15.96.440 – Exterior building materials and color.

Part 3 – Housing Type & Subdivision Design Standards

15.96.600 - Single Family & Duplex Design Standards

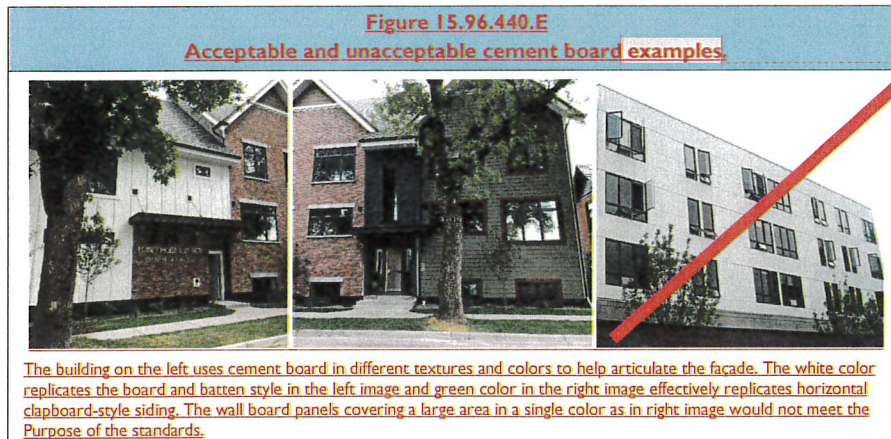
Commented [BB30]: The figure images are from other examples of ours - the good images from Bozeman - but they perfectly fit our proposed standards for Carnation.

Figure 15.96.610.J.2

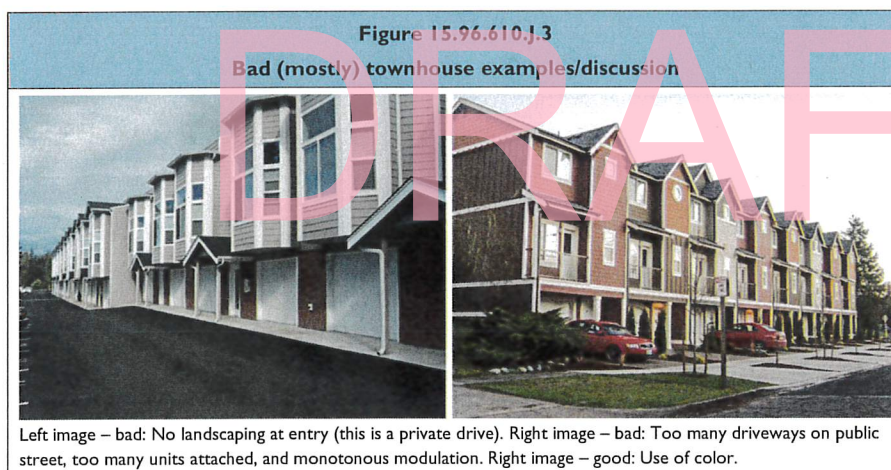
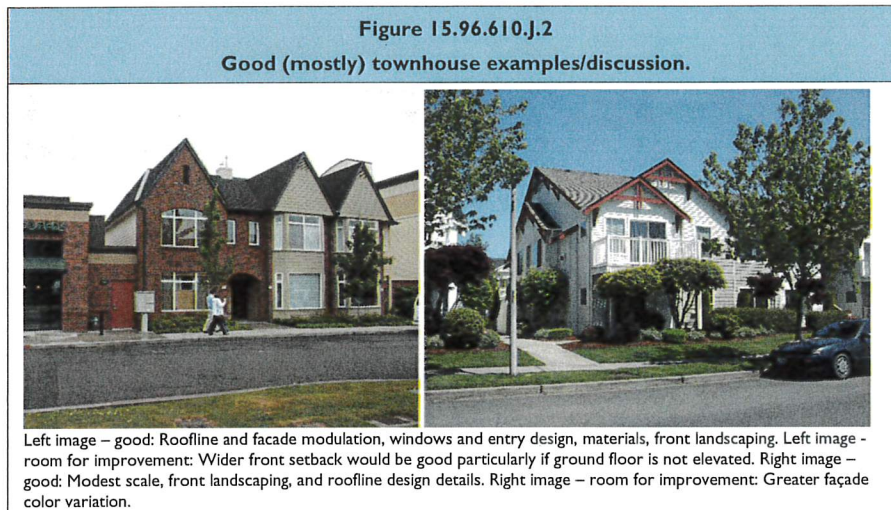
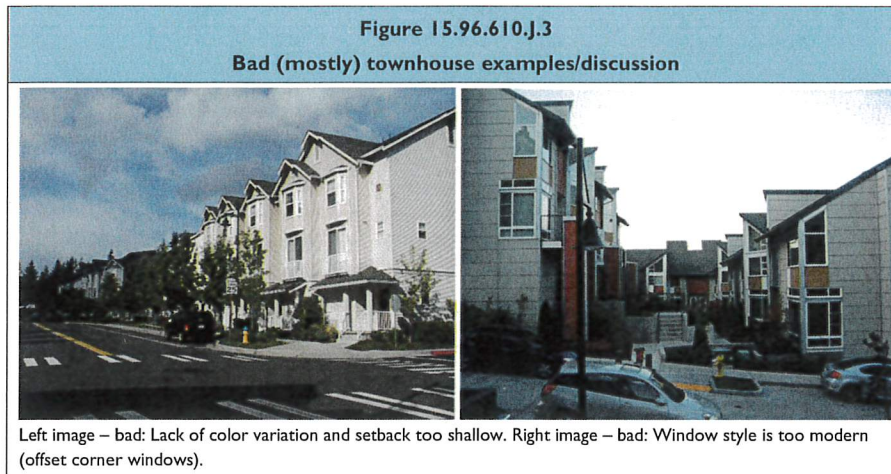
Good (mostly) townhouse examples/discussion.

Left image – good: Roofline modulation, window design, elevated ground floor, and landscaping. Left image - room for improvement: Alternate siding and/or color could improve the design and reduce monotony. Right image – good: Design with balcony in front softens the rest of the façade, roofline variation, siding style. This design with garages/driveways is appropriate along internal drives, but not adjacent to public streets.

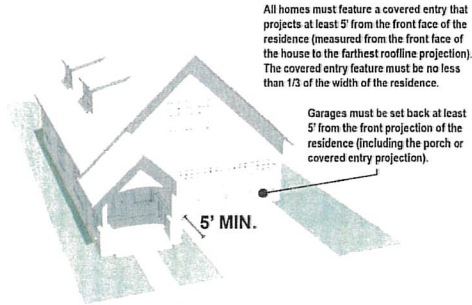
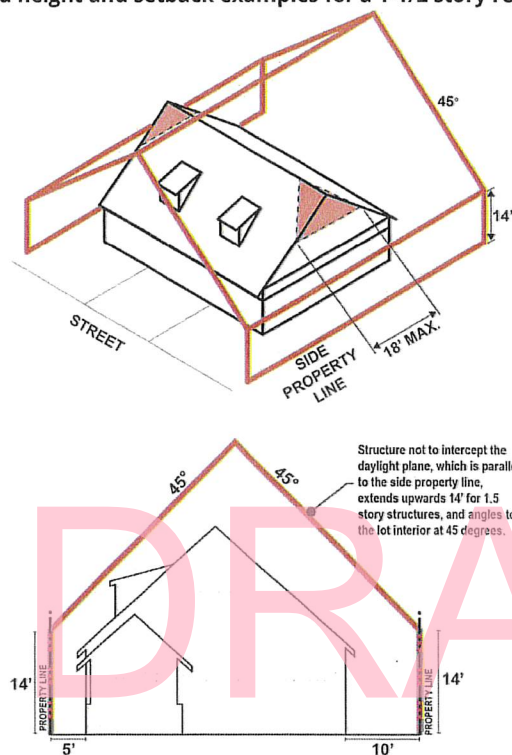
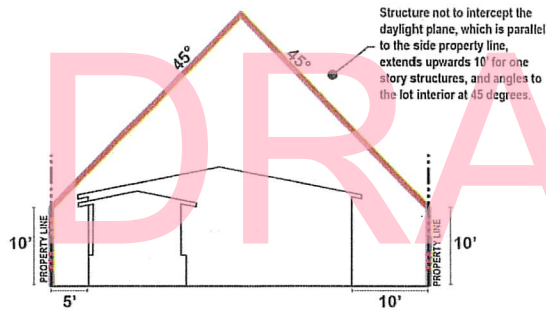
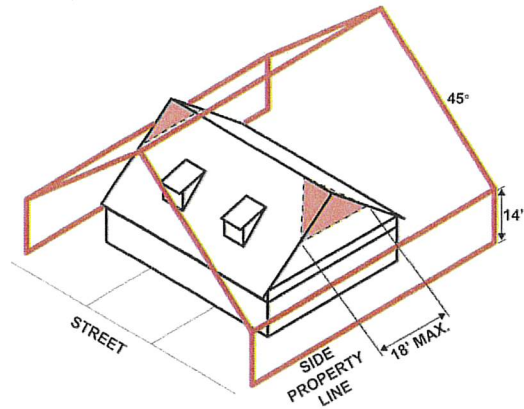
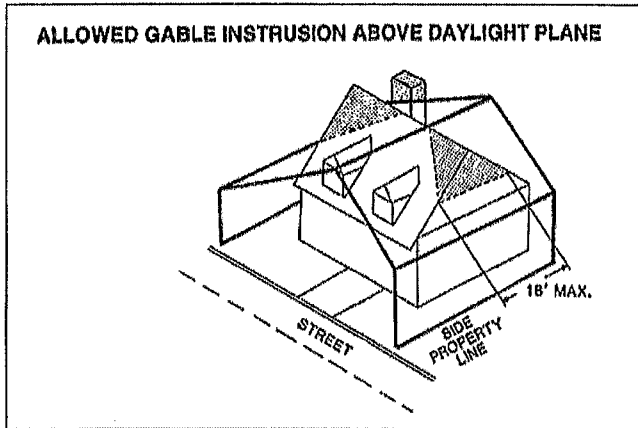
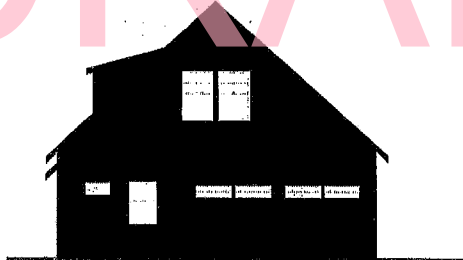
NOTE: We'll update the figures below to be consistent with the others – with the boxes.
